Please find enclosed three (3) copies each of Project Interface Documents (PID), 09-S-20, and 09-S-21 for the Mexican Hat, Utah, Uranium Mill Tailings disposal cell design. These PID's address design changes relating to erosion protection and bedding gradations respectively.

PROJECT INTERFACE DOCUMENT (PID)

Subject Bedding Material Gradation

Subject Revise Grading and Erosion Protection Plan for the Tailings Embankment Final Configuration and Add Requirements for Test Section and Source for Type B1 Riprap.

The proposed changes comply with the calculated gradation limits (see Attached Figure 1).

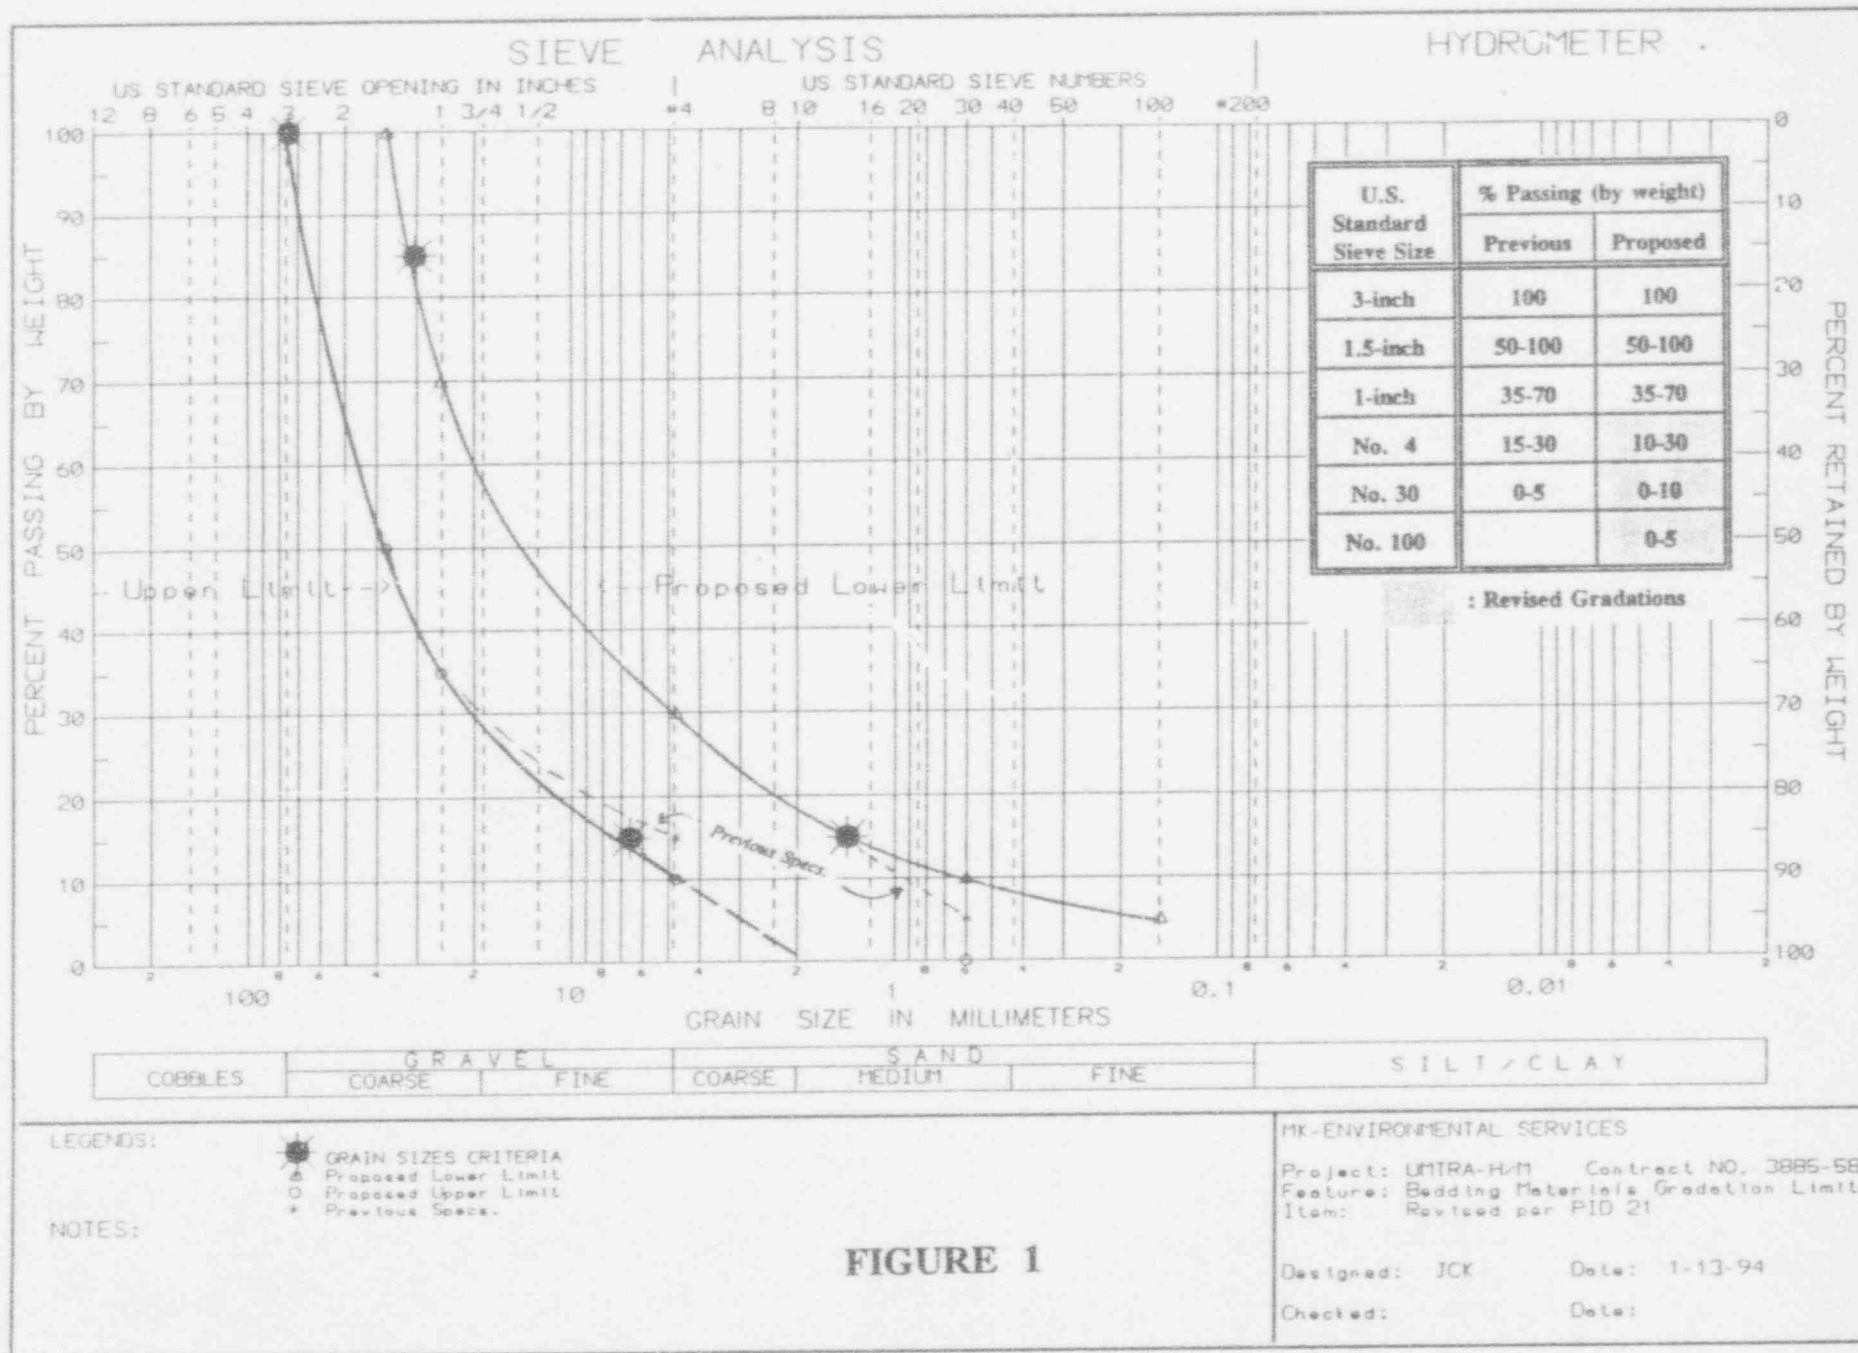
A lot of wastage occurs when processing the bedding material at the Bluff gravel source to meet the specified gradations, specifically for the material finer than No. 4 sieve. Placement of bedding material would also be facilitated and a better surface obtained if the material contained more fine sand. ~~(No. 4 sieve)~~ There will be less wastage and better production if the gradation limits were modified to increase the amount of fine sand.

Amend the gradation requirements for the bedding material as follows: change percentage passing the No. 4 sieve from "15 - 30" passing to "10 - 30" passing. In addition, change percentage passing the No. 30 sieve from "0 - 5"

passing to "0 - 10" passing. In addition, a new sieve size, 5% passing the No. 100 sieve, should be added to the requirements to ensure that less than 5% passes the No. 200 sieve.

In Specification Section 02278, Article 2.4.B.2, the gradation specified for the bedding material will be revised to read as follows:

SKETCH 1

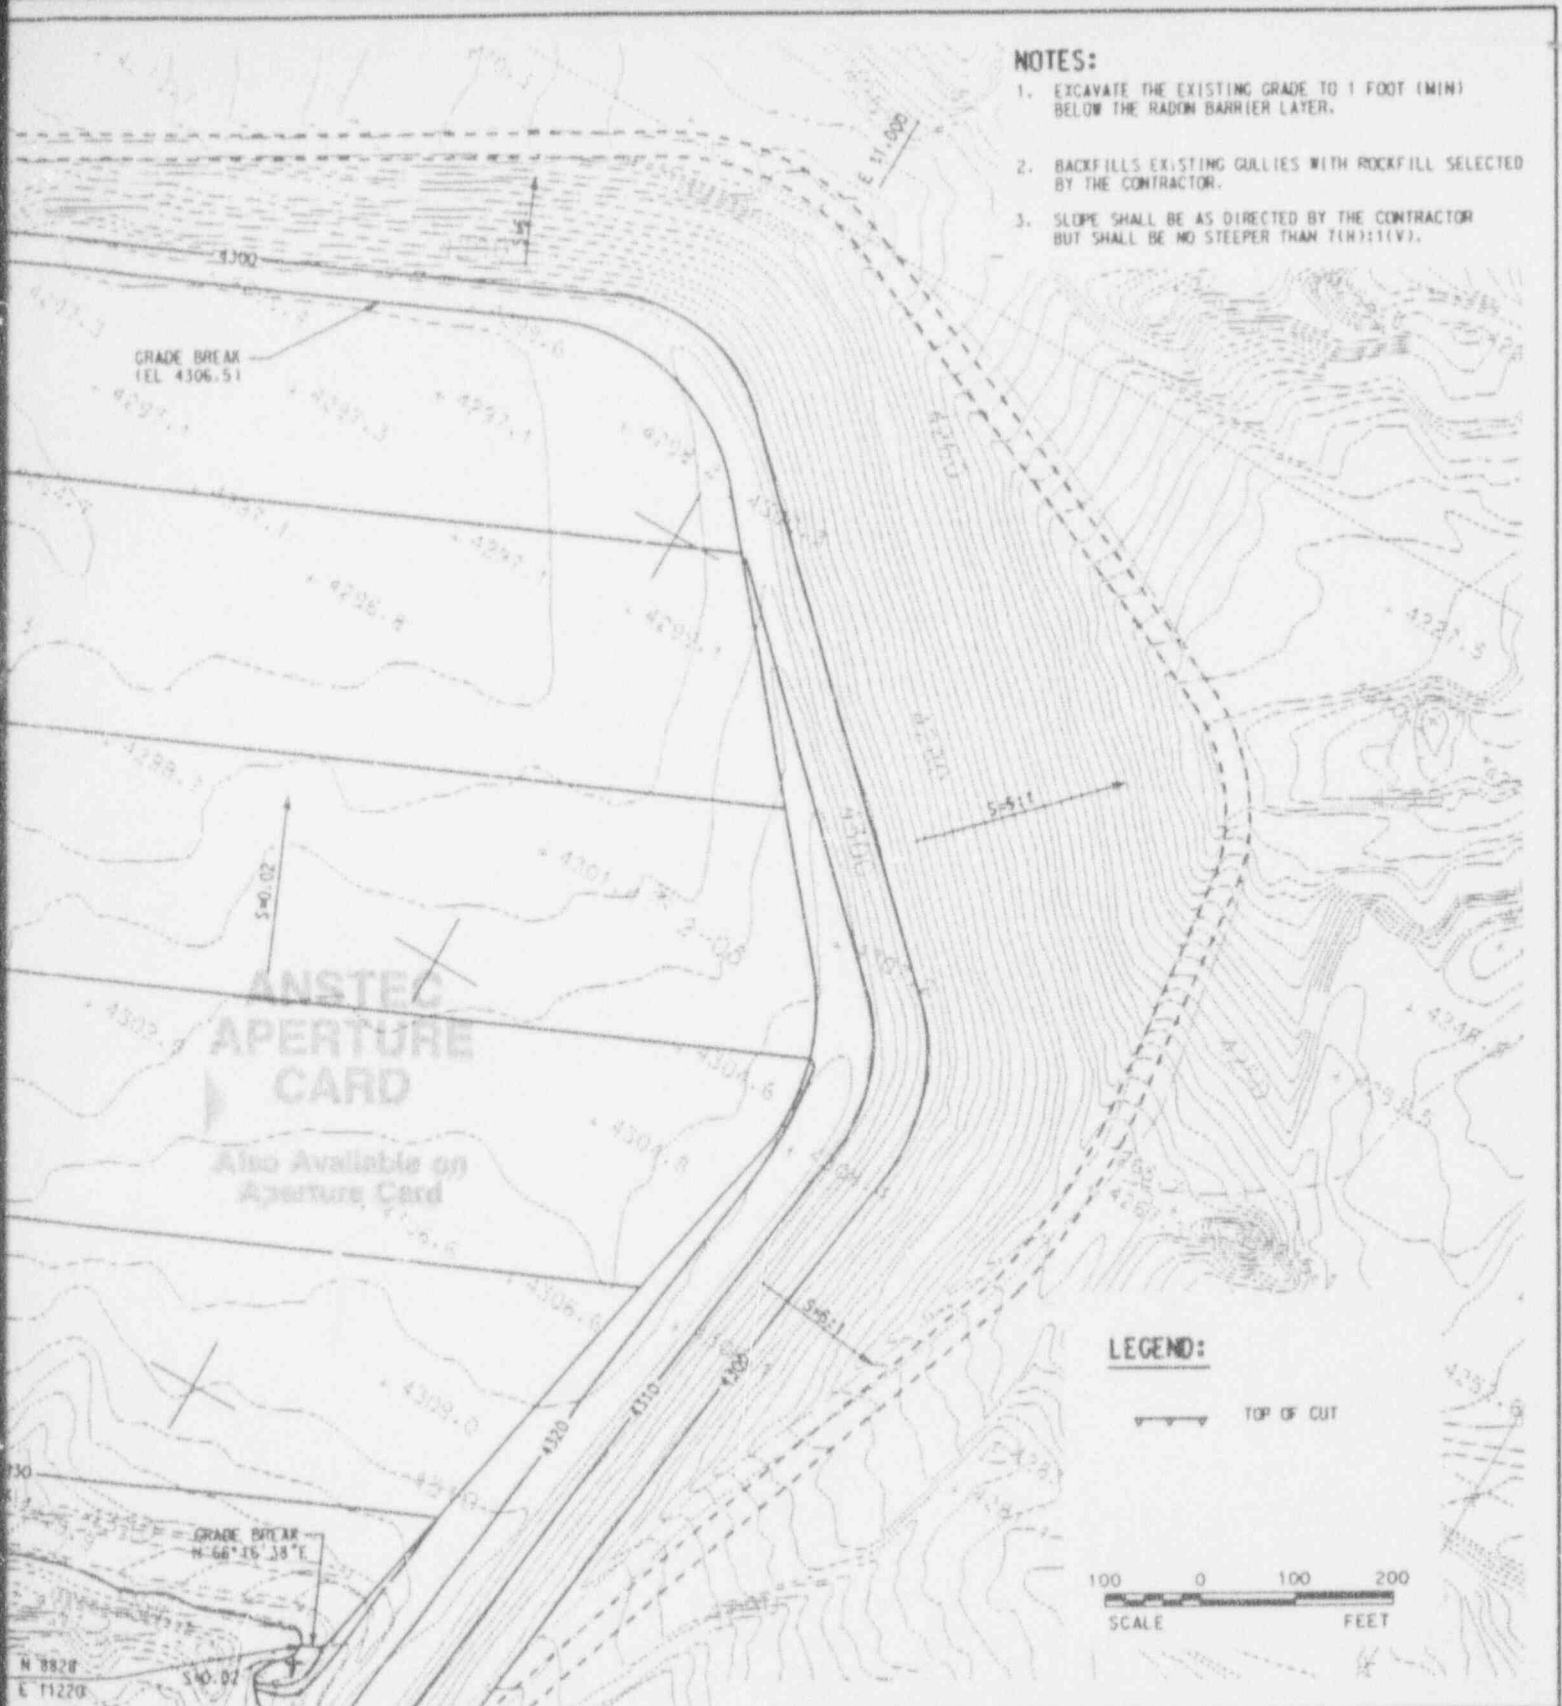
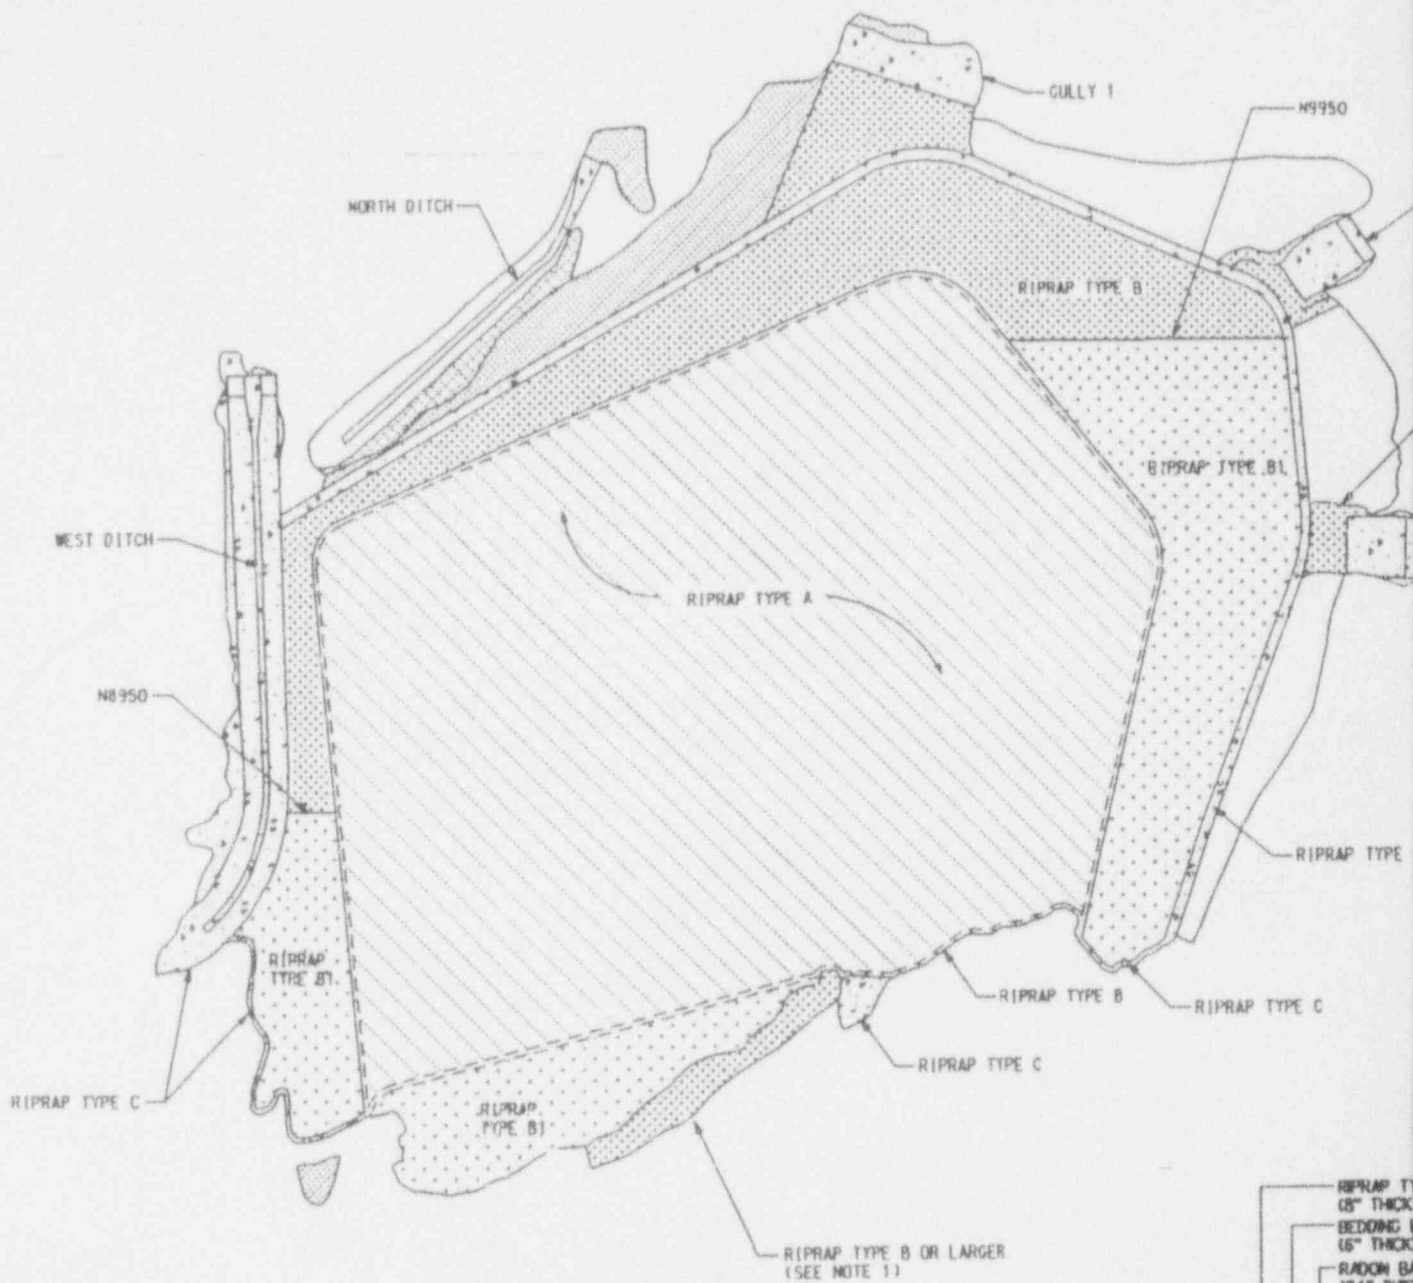
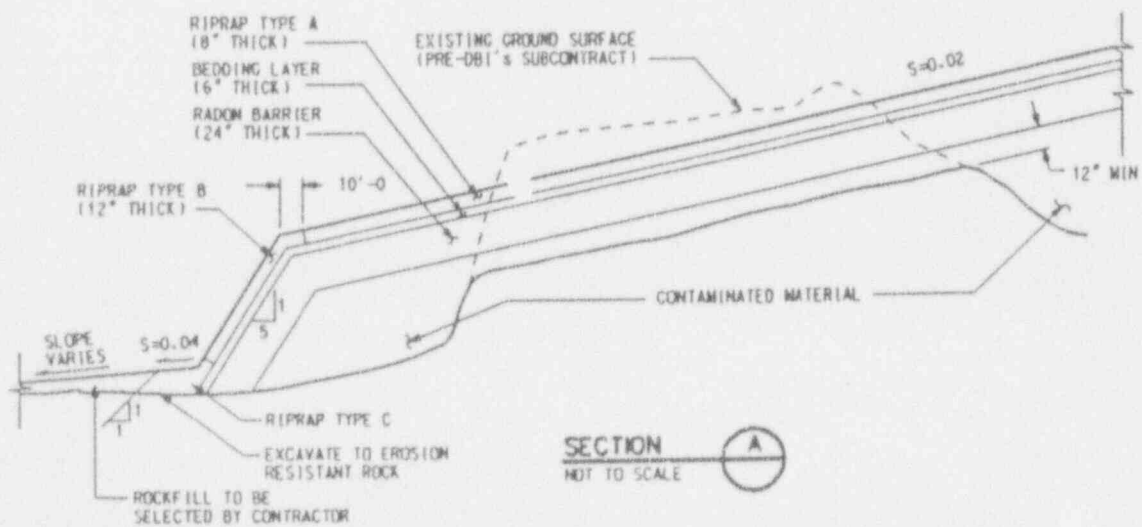
Revise final grading plan of the topslopes and the southwest sideslopes of the tailings embankment as shown on Sketch I and corresponding markups of Subcontract Drawings H/M-DS-10-0212 to H/M-DS-10-0214, as attached. The extent [Continued on the following sheet]

DRAWING NO. **H/M-DS-10-0214** REV. *1*

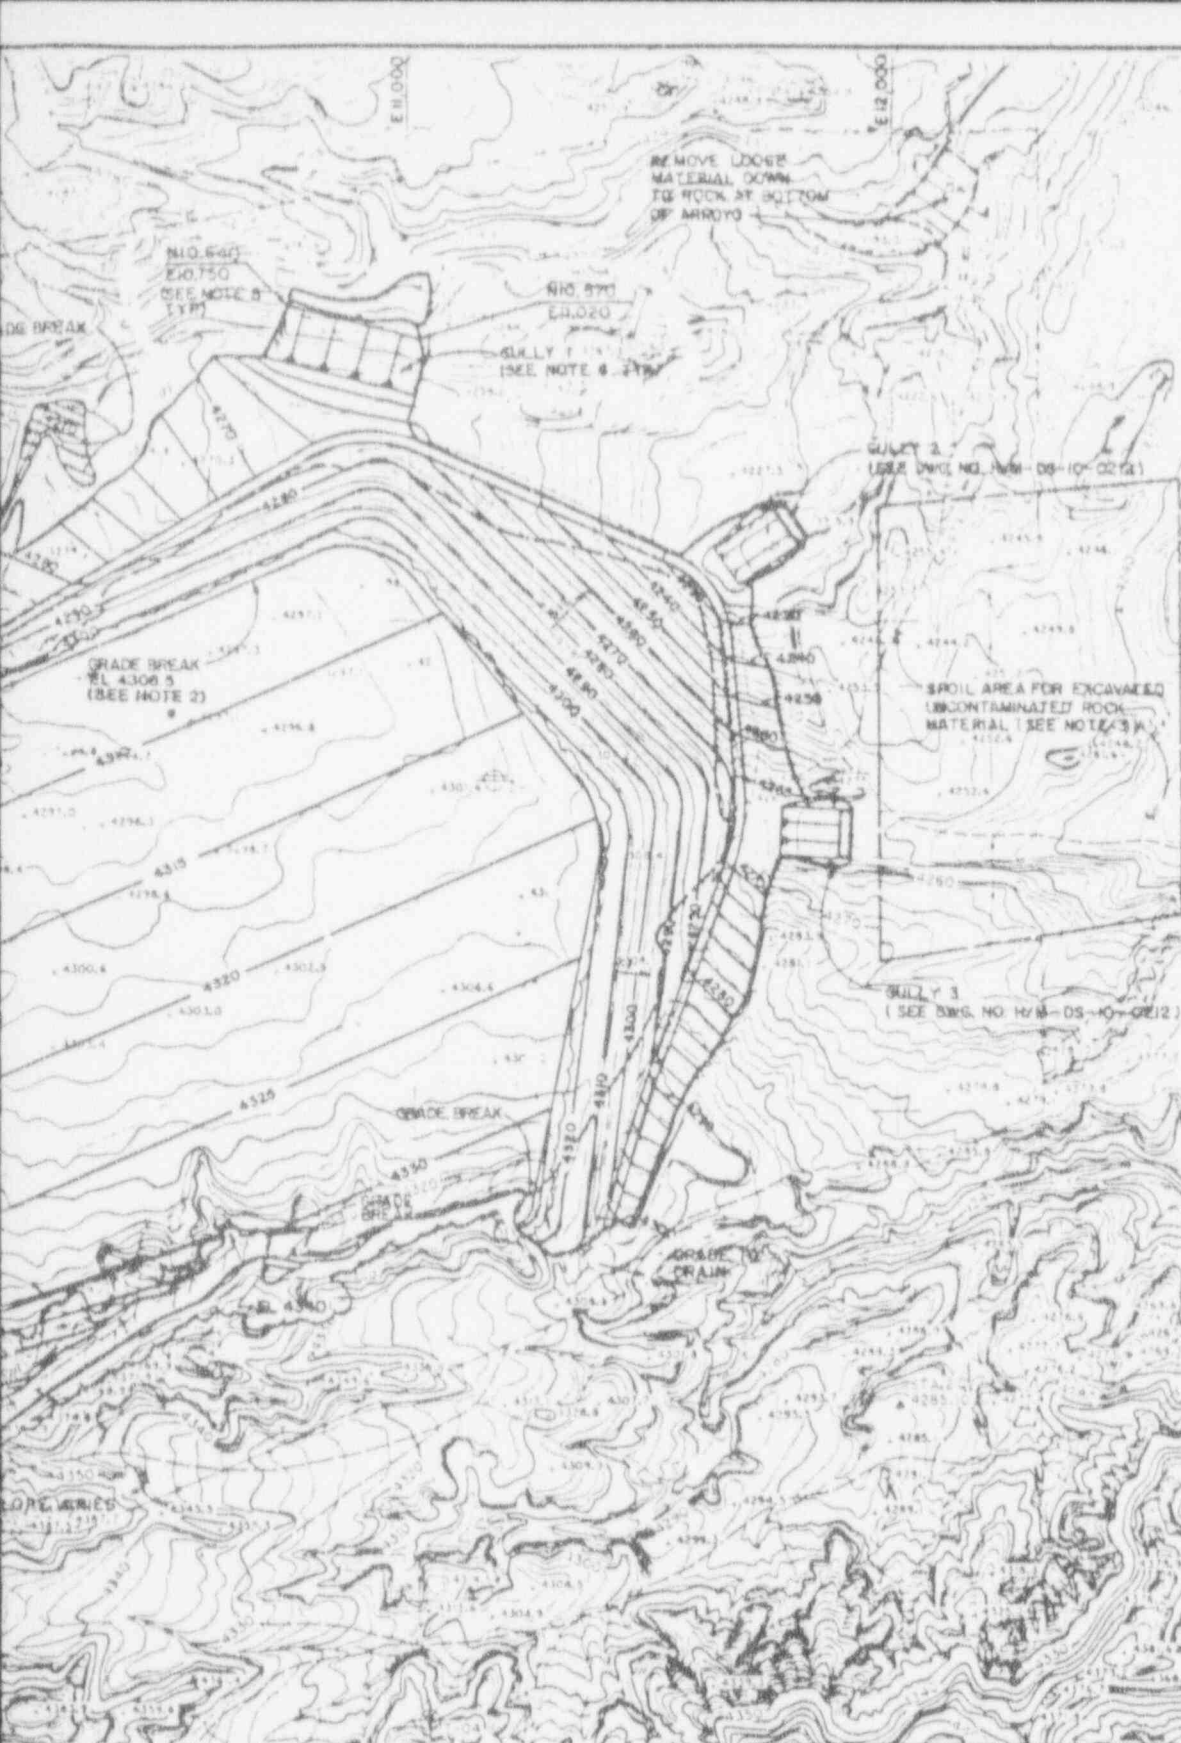
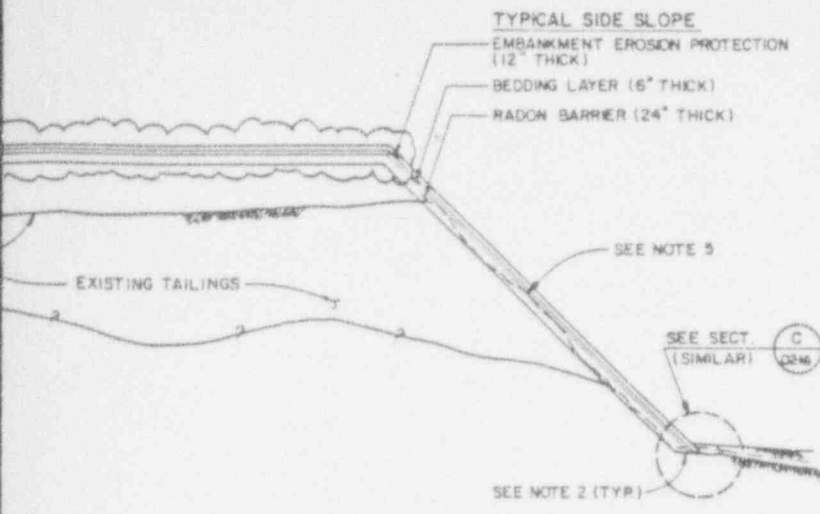
of the Type B1 riprap to be placed and the erosion protection plan and details along the south edge of the tailings embankment shall also be revised as shown on Sketch 2 and corresponding markups of Subcontract Drawings H/M-DS-10-0213, -0215, -0216 and -0219 as attached. The calculation for the proposed erosion protection design is attached (Calculation No. 9-418-14-00).

REVISED AS PER P.I.D. NO. 09-6-20
